**Director of the Manufactured Housing and
Modular Units Program of the Public Service Commission,
Complainant,**

**America's Home Brokers, Inc.
Respondent.**

Case No. MC-2005-0028

Consumer Complaint Time Line

Gray Home - 1/11/05 Inspection Results

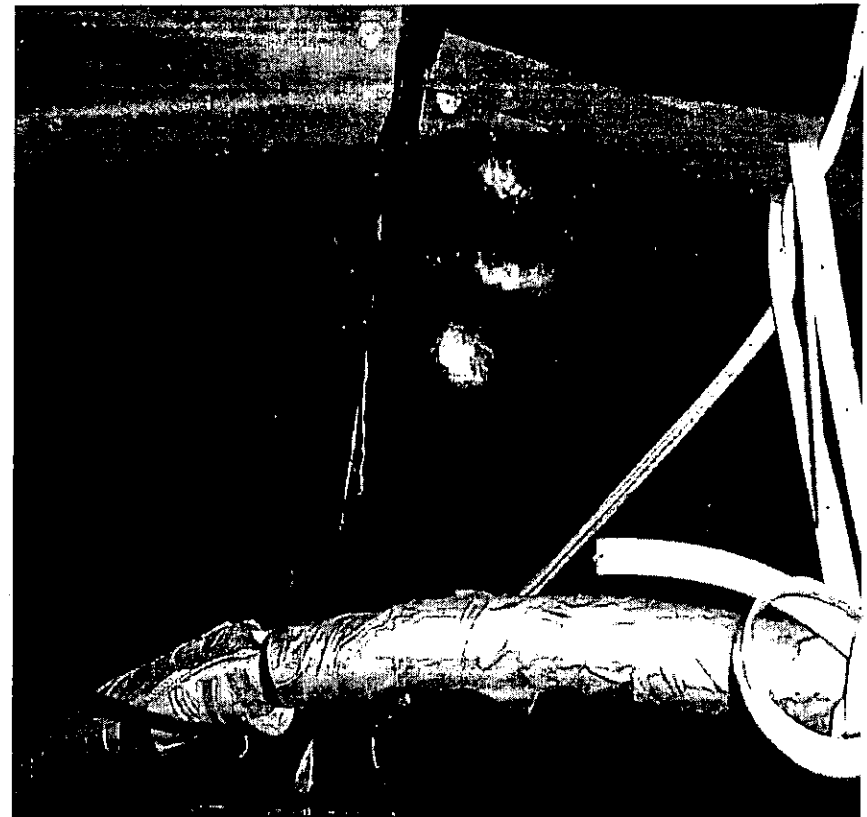
- 4. d) The bolt holes in the bottom board along the centerline of the home need to be resealed.
- HUD 3280.307 (d)
- IM, page 45

Cameron and Sassmann Home

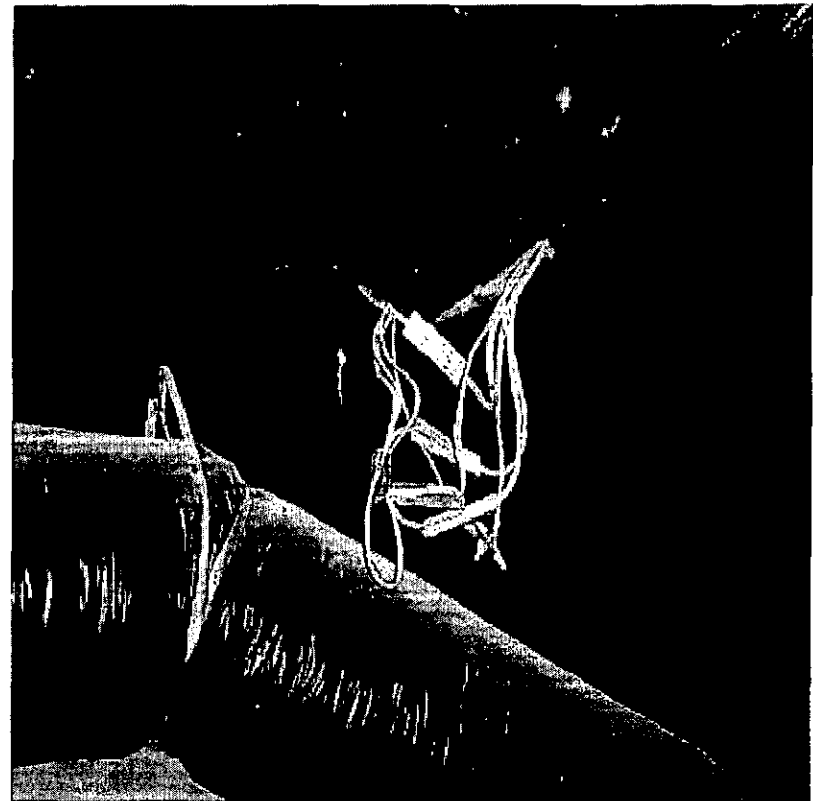
- ❑ 10. c) The crossover electric cables have not been protected in the floor of the home.
- ❑ IM, pages 37 and 41

Cameron and Sassmann Home

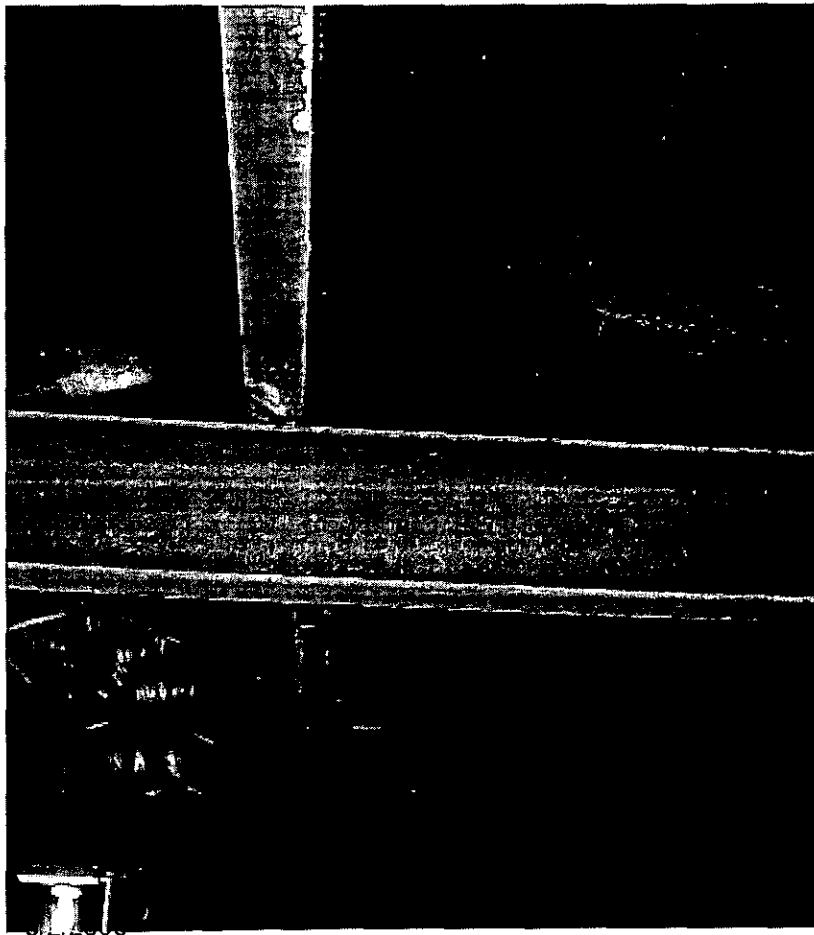
- ❑ 11. The dealer has altered this home by installing a whirlpool in the master bathtub. The dealer must submit an application for permission to alter along with the required documents to the Director for approval and all alterations must be inspected and approved prior to the sale of the altered manufactured home.
- ❑ IM, page 1

Williams Home

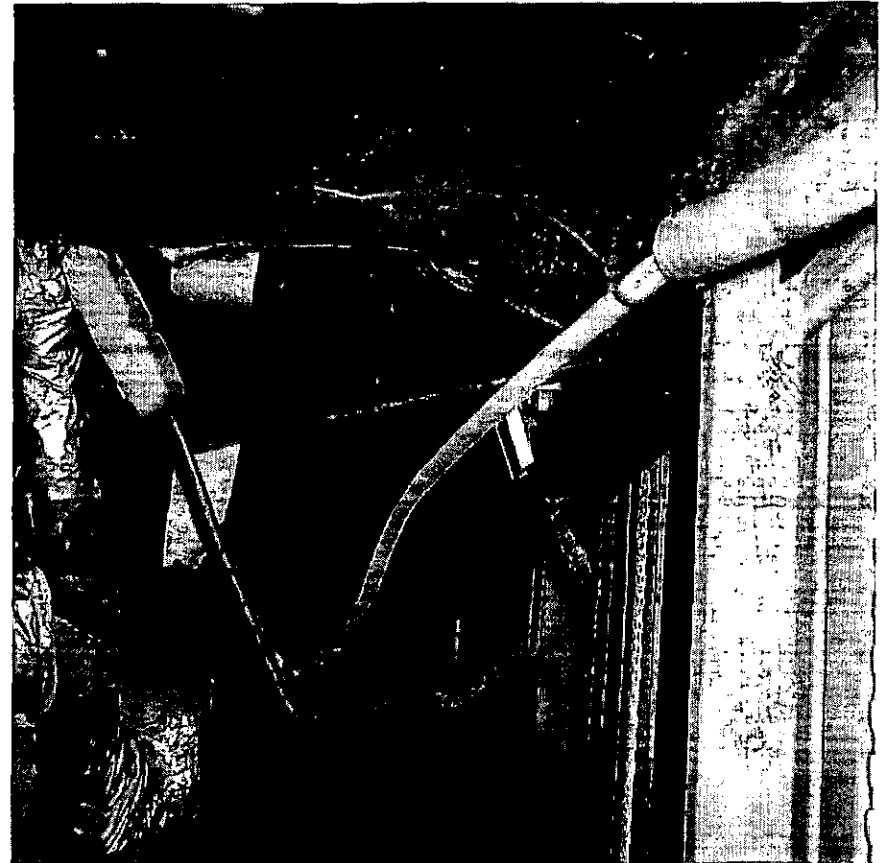
- 10. g) The drain line installed under the home is not strapped every 4' minimum, as required.
- HUD 3280.608(b)
